DEPARTMENT OF PLANNING AND ZONING PLANNER'S REPORT

RE: Design Review – 218 Maple Street

PROPOSED SINGLE FAMILY RESIDENCE REMODEL/ADDITION FOR

ARCHITECTURAL SITE PLAN

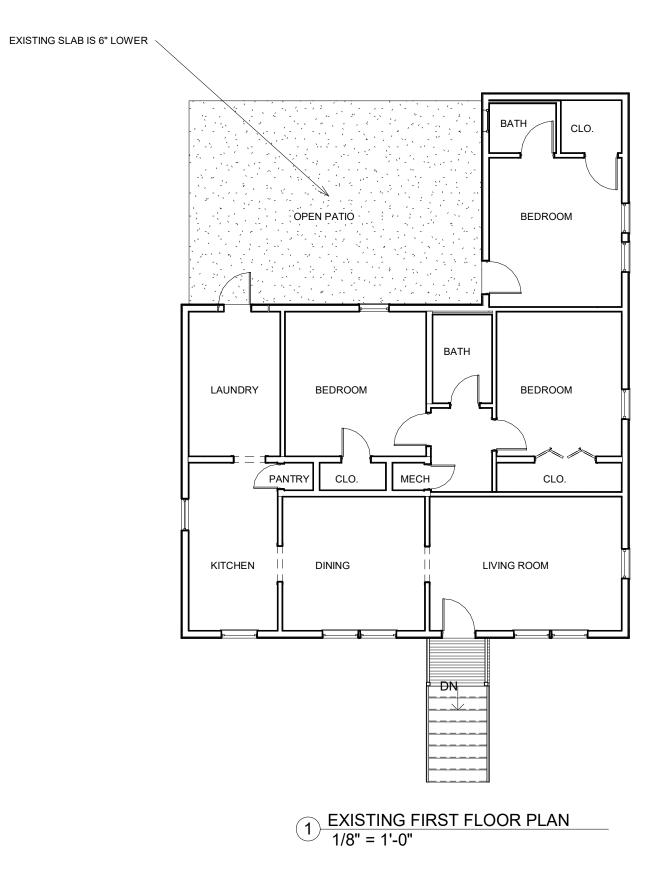
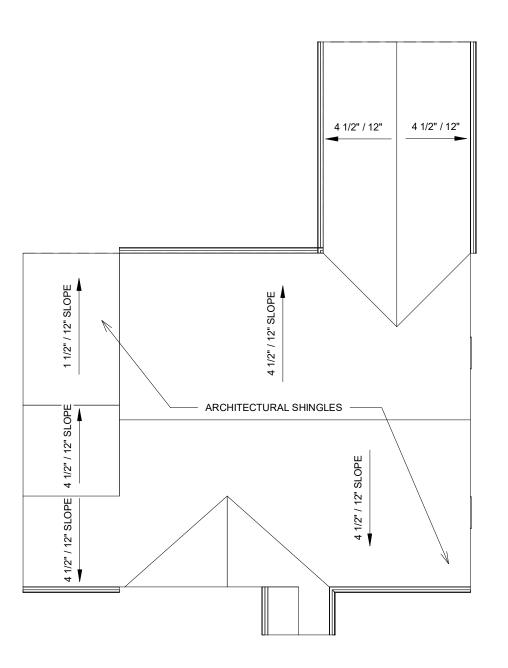
- The side setbacks in the R-1 zone are 5'. The existing dwelling is 4.6' away from the western property line, which is not compliant. The applicant has applied for a Variance from the board of appeals to reduce the side setback.
- Within subarea E, the maximum height for the portion of a building closer than 5' to the property line is 16'. Both the existing and proposed structures have a uniform east-west height of 19' 2 1/2", which is not compliant. The renovation is repairing/replacing the roof and altering the roofline but is not changing the overall height of the structure.
- The existing sidewalk does not have a landscape area.

The location and width of the driveway is not provided on the site plan. The scope of construction does not include changes to off-street parking.

- 5. The applicant has indicated there will be a light at the front door. The plans should be revised to show the light.
- 6. The location and width of the driveway is not provided on the site plan. The scope of construction does not include changes to off-street parking.
